Product Change Notification / SYST-23CMIU808

ERRATA - dsPIC33CK256MP508 Family Silicon Errata and Data Sheet Clarification

Description of Change: Added data sheet clarification 3 (Electrical Characteristics).

dsPIC33CK256MP508 Family Silicon Errata and Data Sheet Clarification

FIGURE 1-1: I/O RAMP

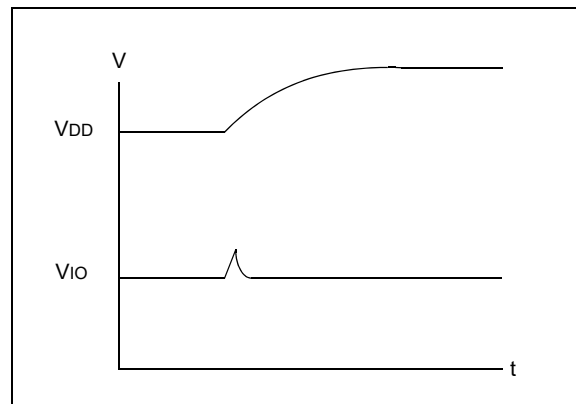
24. Module: I/O

1. Slow down the V_{DD} ramp time (greater than 4 mS for V_{DD} to ramp 0V to 3.3V).
2. Ensure the circuitry that is connected to the pins can endure this pulse.

Example applications affected may include complementary power switches, where a transient current shoot-through might occur. High-voltage applications with complementary switches should power the high-voltage 200 μ Sec later than powering the dsPIC[®] device to avoid the current shoot-through. This behavior is specific to each device and not affected by aging.
